**From:** Watkins, Robert  
**Sent:** Wednesday, November 20, 2019 11:46 AM  
**To:** csallwasser@gropen.com  
**Cc:** Werner, Jeffrey B  
**Subject:** November BAR Action - 946 Grady Avenue

BAR 19-11-01  
946 Grady Avenue  
Tax Parcel 310060000  
Dairy Holdings, LLC, Owner/Charlie Sallwasser (Gropen), Applicant  
Signage Plan

**CITY OF CHARLOTTESVILLE  
BOARD OF ARCHITECTURAL REVIEW  
STAFF REPORT  
November 19, 2019**

**Recommendation on Signage Plan**

**1** Front Elevation **MONUMENT SIGN C.0** ■ **24 SQ FT**  
Scale: 1" = 1'-0" **Quan: (2)** Two-Sided

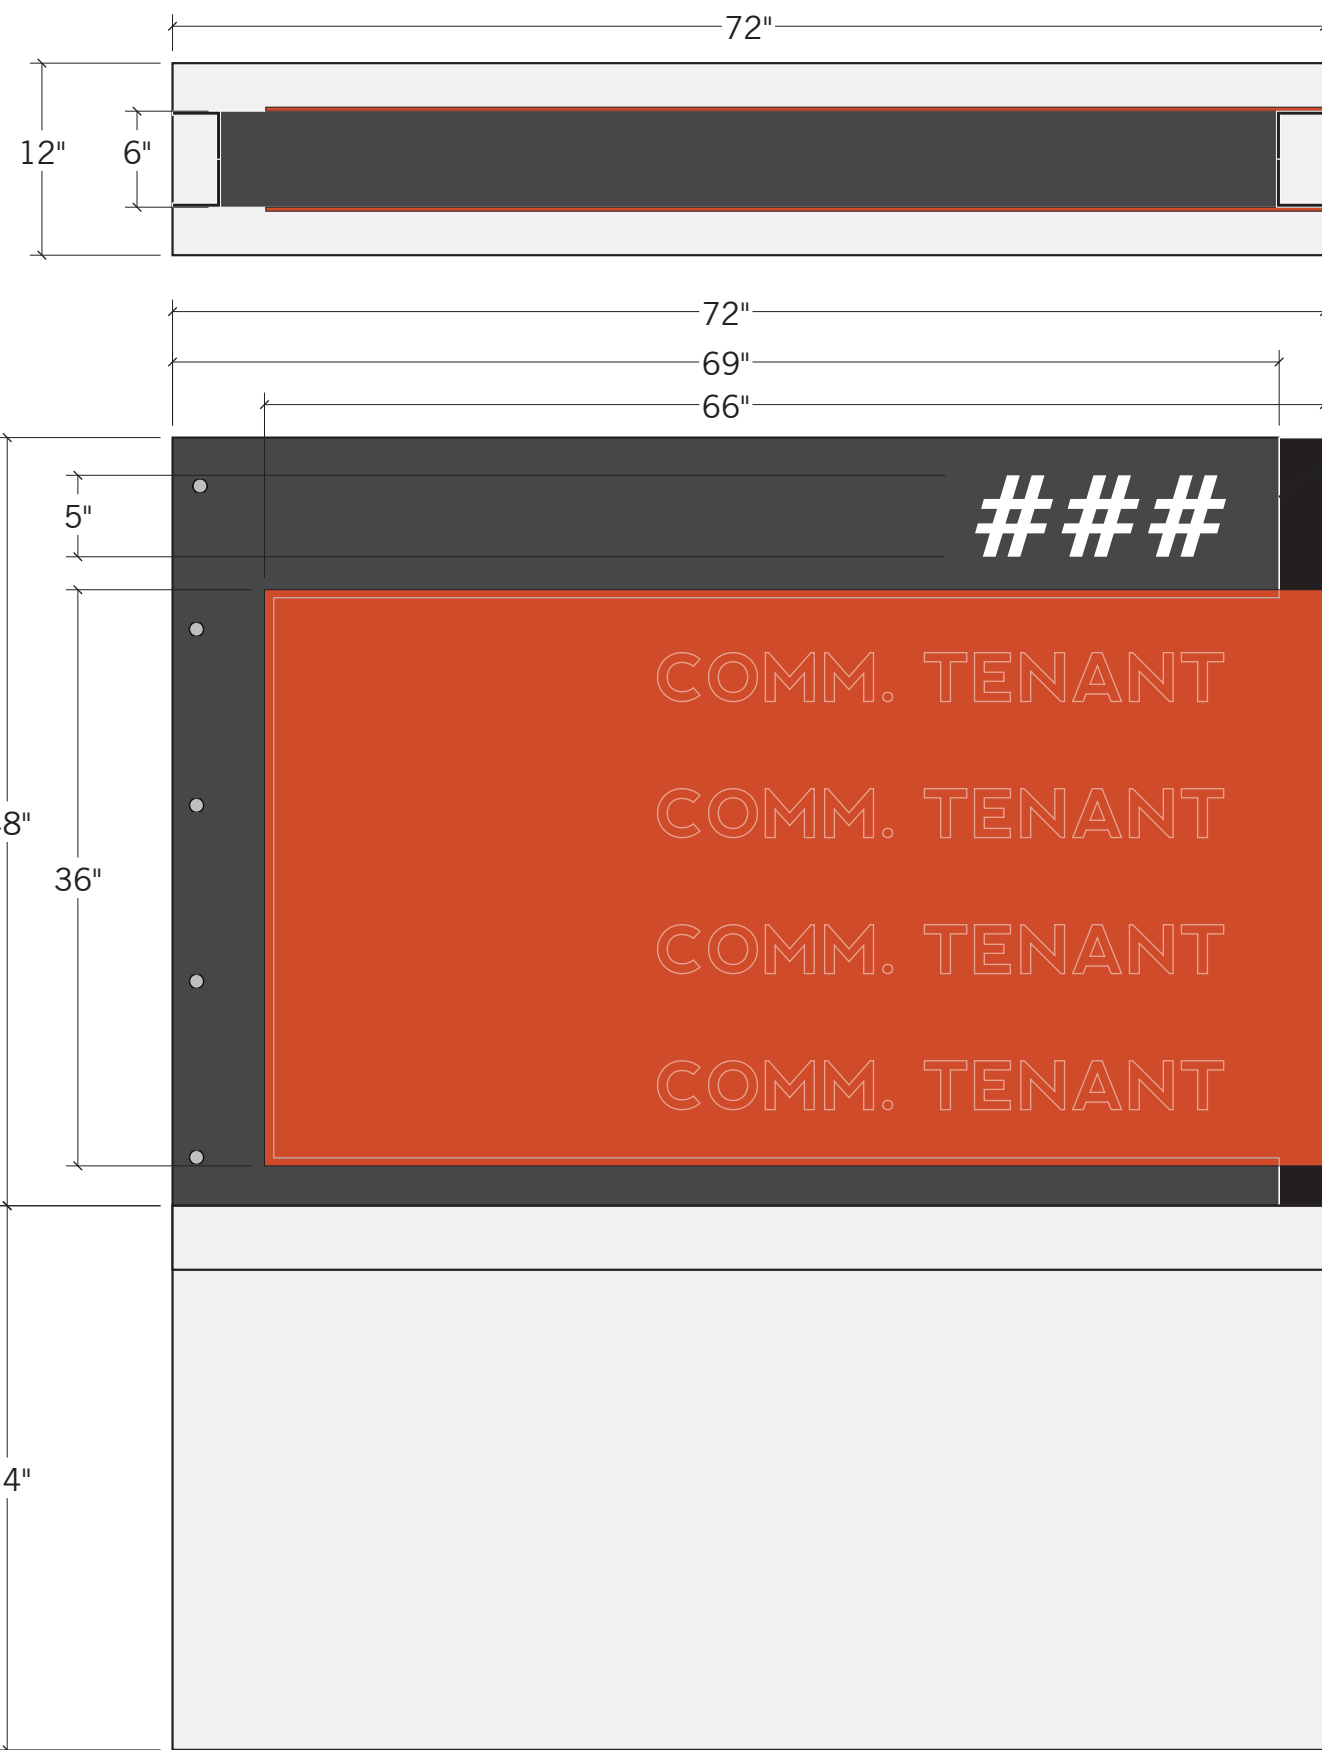
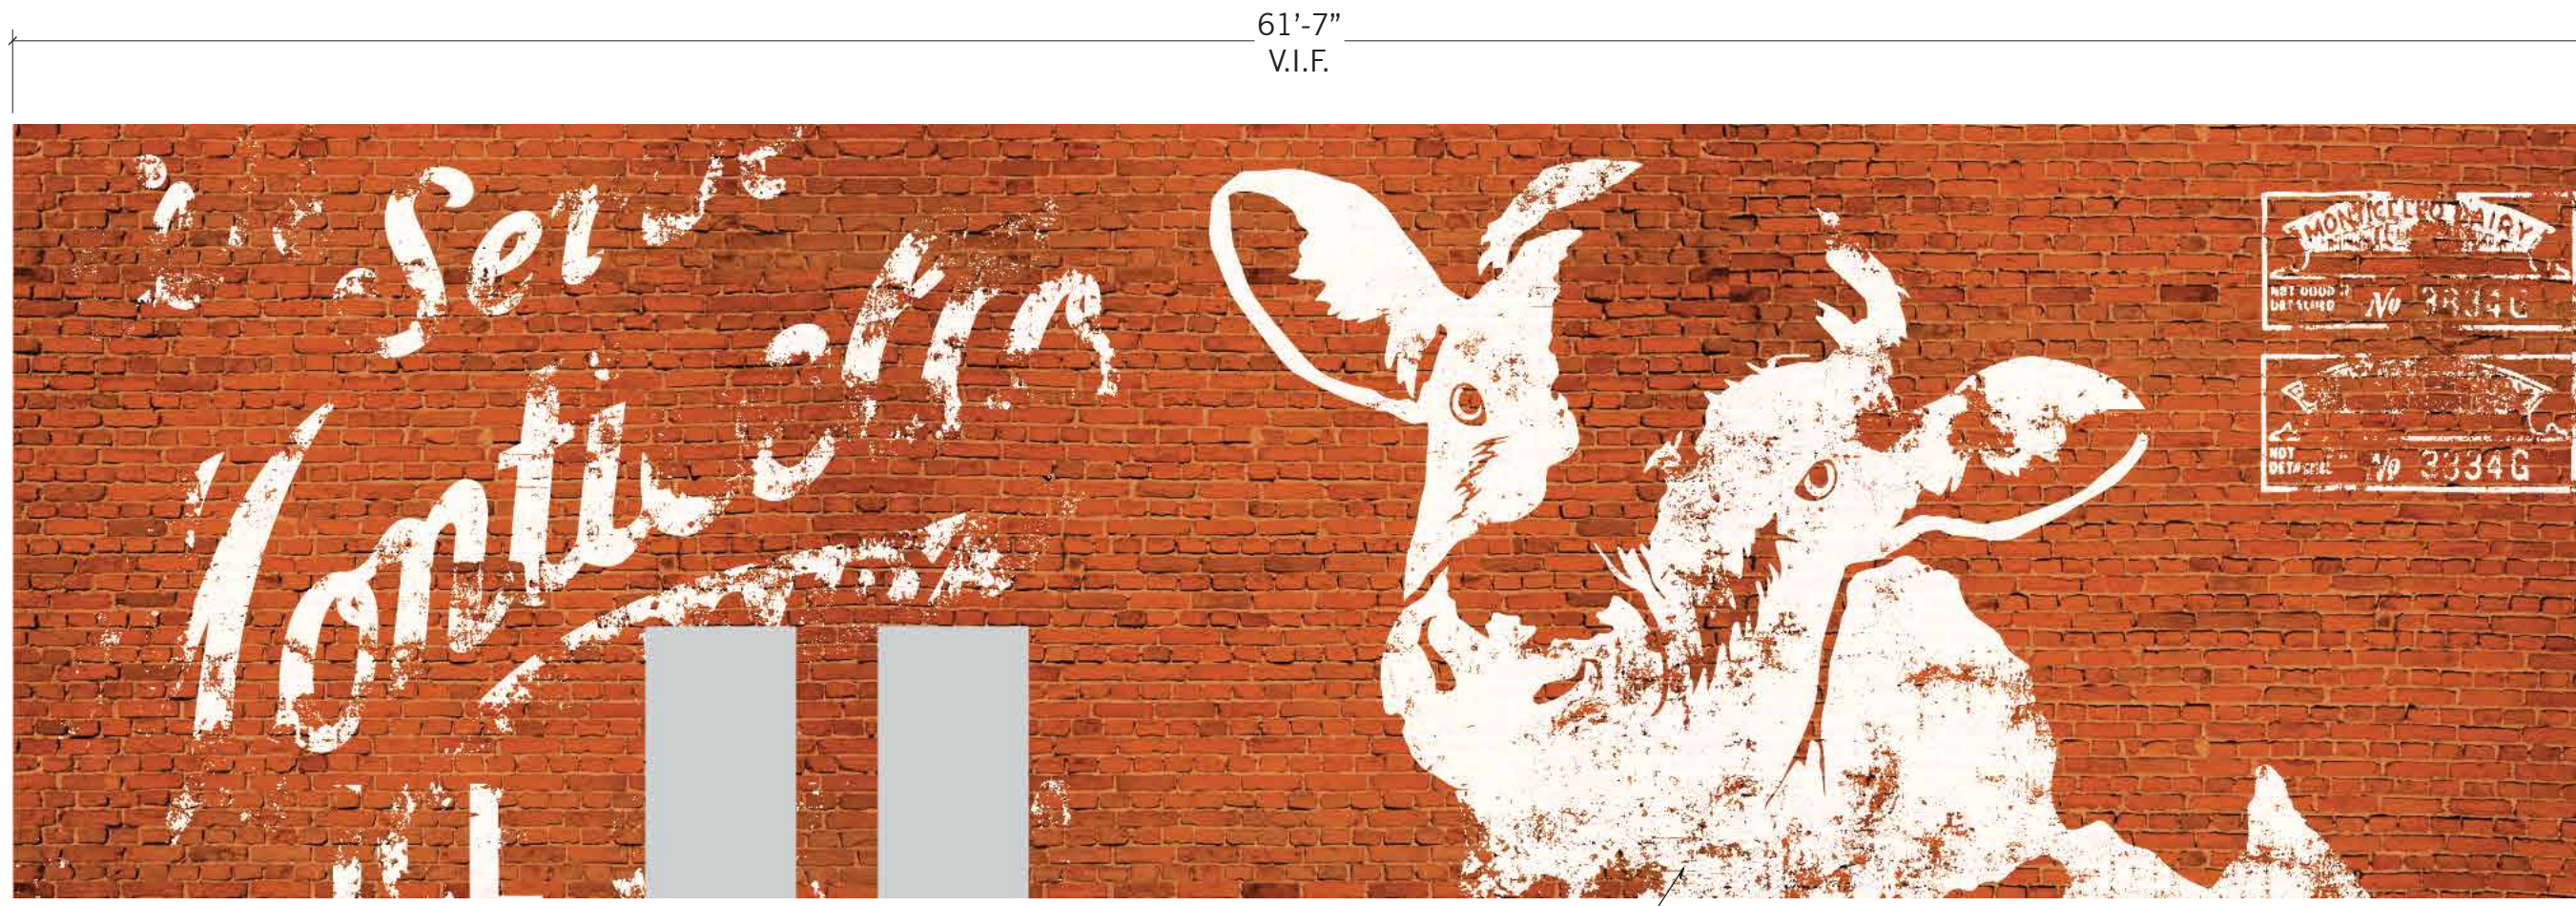
- Monument Sign C.O:
  - Proposed high of 6’-10” exceeds the 6’-0” maximum indicated in the January 2018 submittal. The Design Guidelines do not specifically address monument signs, but recommend that freestanding signs not exceed a height of 12’-0”. The proposed signage is within this, however the BAR should discuss if the proposed height is appropriate.
- “T”-Type Signage:
  - Lettering shown with max height of 18”. Design Guidelines recommend 12” – 16”
- Color Palette:
  - Does proposed palette complement the materials and color of the building, including accent and trim colors?

WALL MURAL

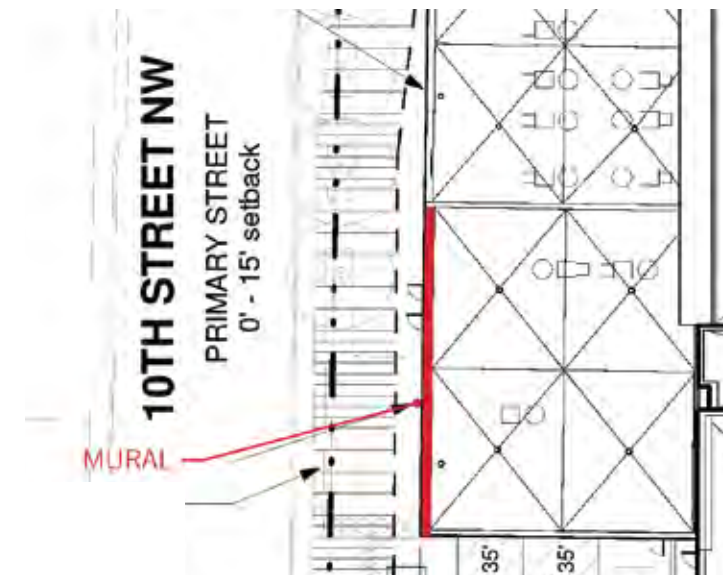
- **That there be no signage on the building higher than the sills of the second floor windows**
- **That the mural should not be painted with faux fading, as it presents a false historic narrative. The BAR otherwise supports the mural.**

Per discussions with zoning staff, the CSP is necessary in order to permit the mural on the west elevation (see page 4 and location on page A2.10), allow one area of signage on the north elevation to exceed at height of 20-feet (see page 5 and location on page A2.10), and allow a third monument sign.

**A2.10**

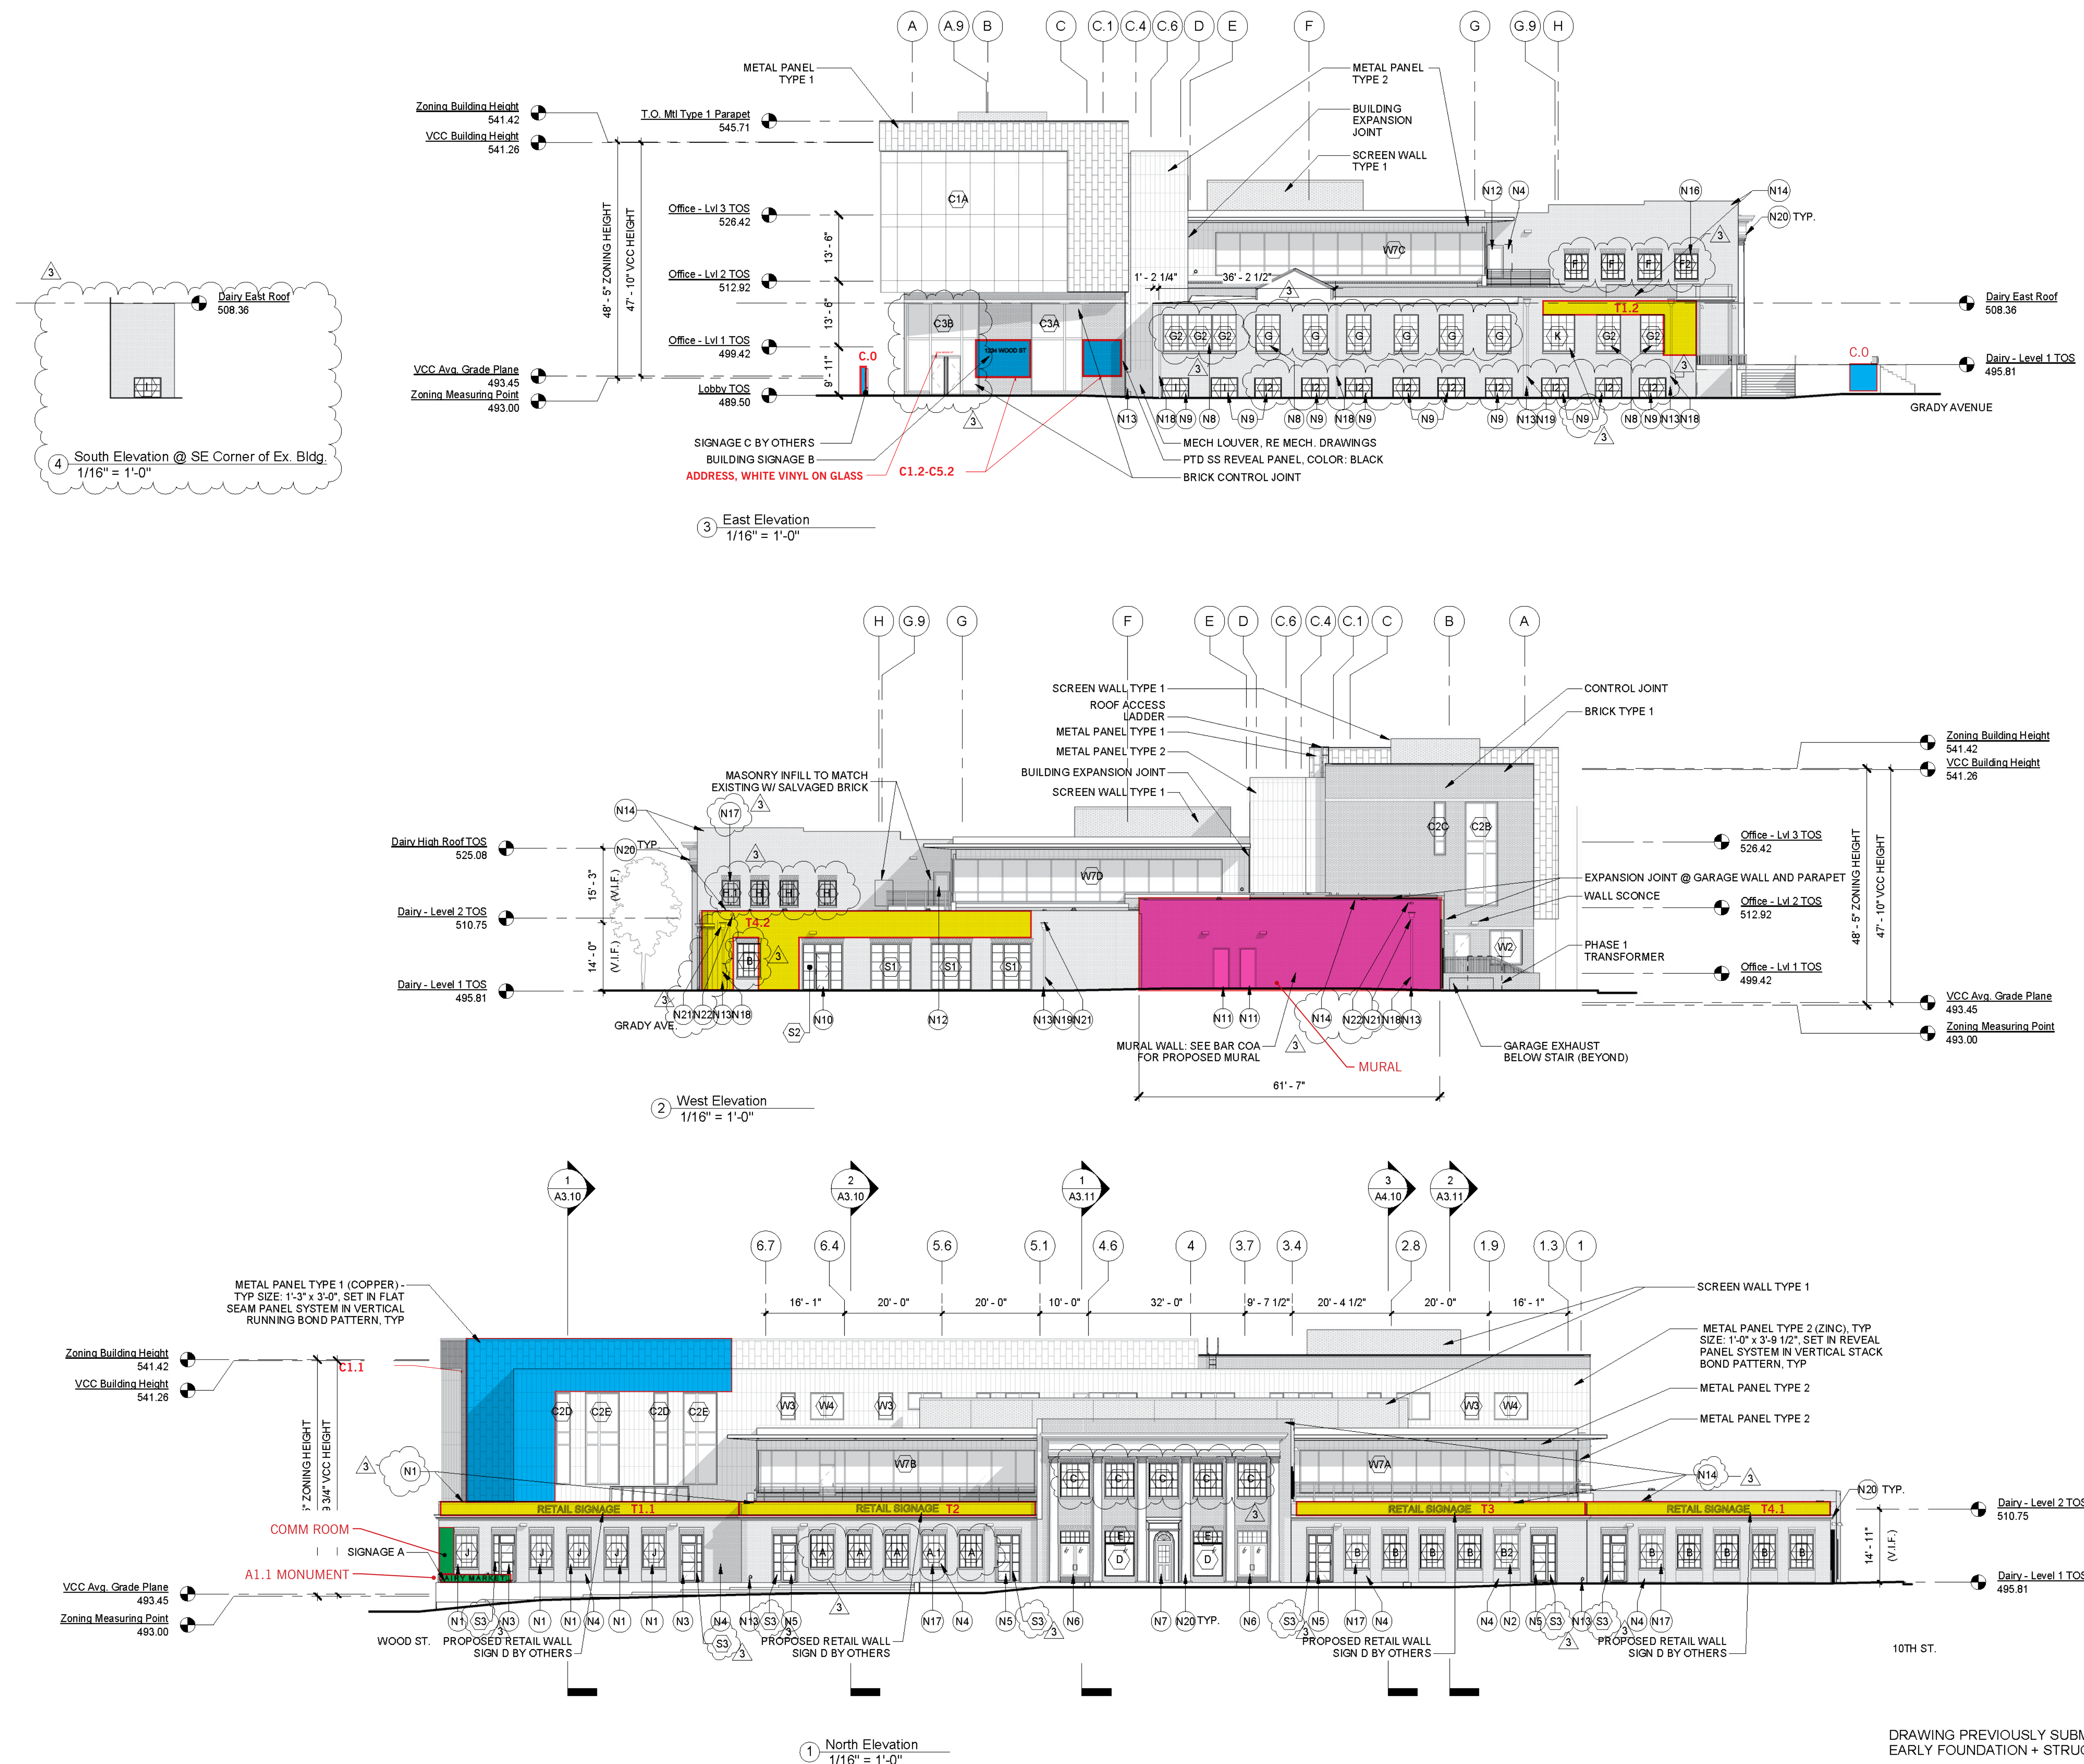
i. Wall signs (Refer to elevations on page A2.10. *Shaded areas* indicate locations where signage of the stated sizes can be installed; not the total area/size of the proposed signage.)
